From: Griffin, Tim
Sent: 29 January 2024 17:00
To: Sharpe, Summer
Cc: Dyer, Tim; Stringer, Chris
Subject: Re: F/23/96573 Boundary Lakes Golf Club, Moorhill Road, Eastleigh, SO30 3XH - landscape comments

My comments below focus on the Visual Impact Assessment and the Johns Associates Landscape Masterplan.

TMF Architects Site Masterplan

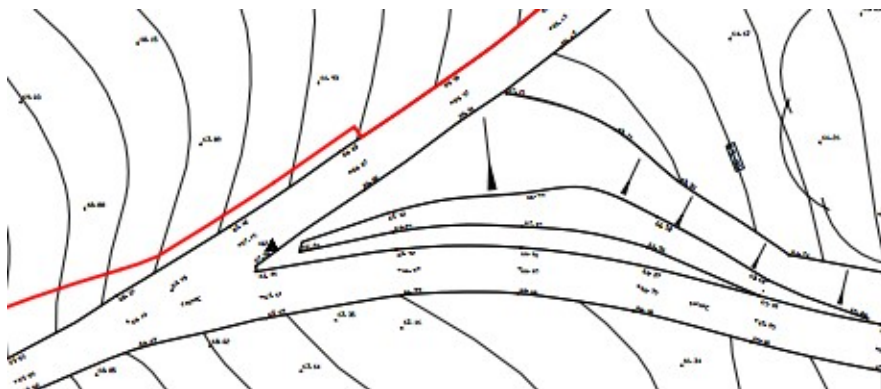
4/ I am not clear as to the intentions with the spur drive shown on the existing site plan (labelled as Anne Rose Way on Google)?

The section across the site is being removed, but what will happen to the remainder of this drive that appears to link with an adjacent route? Some additional notes on plan would provide helpful clarification.

Johns Associates Landscape Masterplan

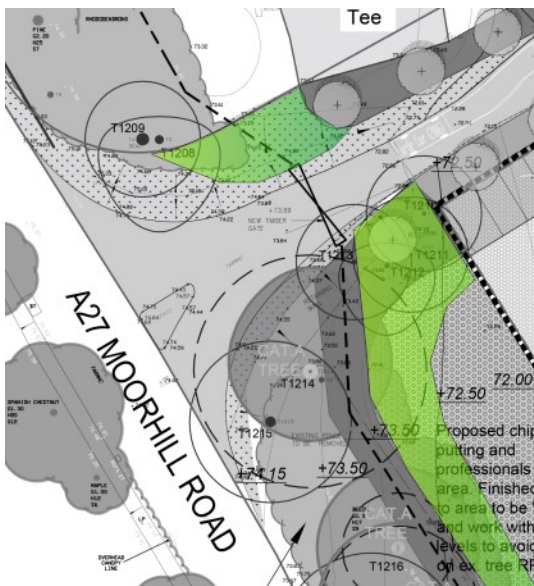
5/ Provision of robust Green Infrastructure and enhancing boundary screening is fundamental to the success of this site. Although the proposed native tree and structure planting go some way to softening the impact of the scheme, further planting is required in key locations. It is critical that there is new native screen planting either side of the entrance where a number of existing trees are either dead or being felled as part of the development. The planting to bolster the screen to Moorhill Road should be moved out from under existing trees (see markup below) and further new trees shown to ensure successional growth.

6/ The proposed chipping, putting & professionals lesson area is not acceptable. The area is too close to the main road, difficult to access and may negatively impact retained trees. Please omit this facility to free up the area for screen planting and species rich wildflower grass.

7/ The proposed low retaining walls highlight the significant level changes on the site. The site slopes down from west to east by over 10m. Gabion walls are preferred but these should be kept under 0.6m high to avoid the need for safety railings.

Further detailed design work on levels is needed to provide comfort that the proposals are deliverable. Any areas of cut and fill should be detailed, and any necessary guardrails shown on plan.

9/ The 'lobe' of proposed grass adjacent the service parking should be replaced by shrub planting

10/ The planters either side of the steps/ramp to the entrance are too narrow for planting to succeed - omit.

11/ Whilst I defer to comments from the Tree Officer, in my opinion the location and design of the attenuation basin is not acceptable and should be re-visited to pull the feature away from existing trees and to ensure the basin is designed in a naturalistic way, working with, not against the contours. The basin should be designed as a feature, with at least some standing water year-round so the basin is not just a barren 'hole in the ground'.

12/ Please confirm the proposed putting green will not require any earthworks within the RPZ of the retained Cat A trees.

13/ The route of the proposed foul sewer could adversely affect retained trees (especially T1220). Further detail required.

14/ Shrub and groundcover planting to be pulled back approx. 0.4m from edges/end of parking bays.

15/ Any sections of Sedum Green Roof to be shown on plan.

16/ Further details of the gate and entrance signage to be provided

17/ Please indicate on plan the section of existing drive to be removed, together with specification notes detailing remedial works to prepare the area for grass seeding.
